Publication No. MB 3058-44
1/96

MODIFICATION INSTRUCTIONS

KODAK X-Omatic MULTILOADER 300

MODIFICATION No. 44

figure 1

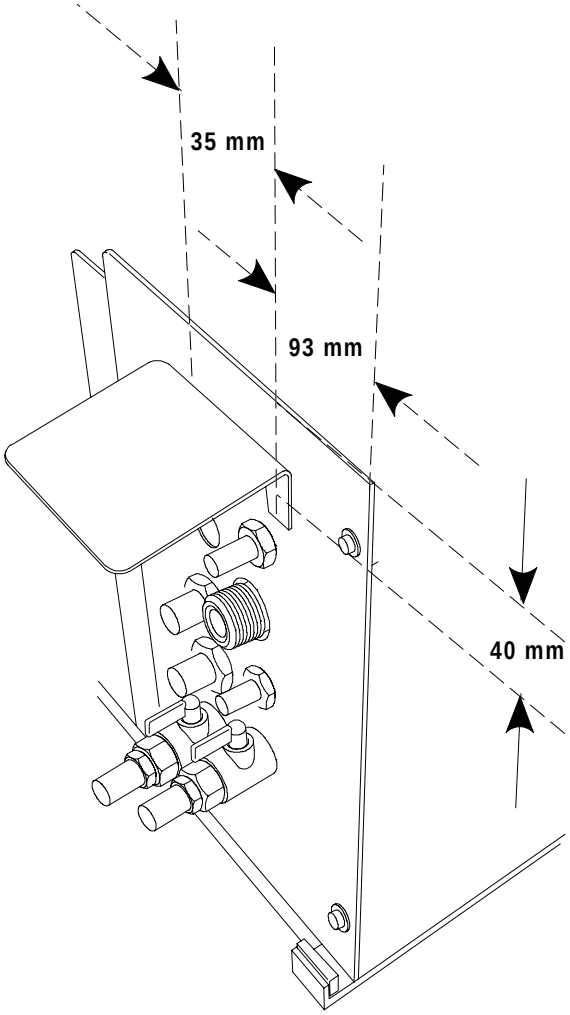
The PROTECTIVE PLATE will prevent the FITTINGS from breaking if a CASSETTE falls down behind the XML300.

3. Mark the position of the 2 holes. See figure 1 on page 4.

4. Drill two 5 mm holes and remove all burrs.

5. Mount the PROTECTIVE PLATE. Use SCREWS, NUTS and WASHERS from the KIT.
